Accessibility Design Review Report

Project Title: Neringah Seniors Housing & Hospital
4-12 Neringah Avenue South, Wahroonga

Report Version: 22226_ADR_DA_v1.1

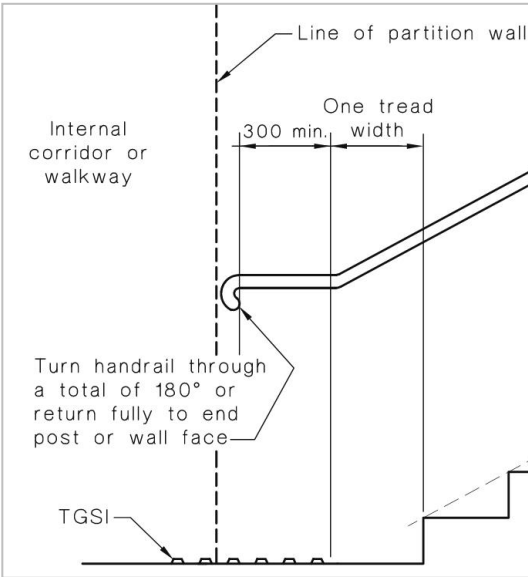
Ensure level transitions or compliant ramps with landings are provided between internal and external areas (refer to mark-up options).
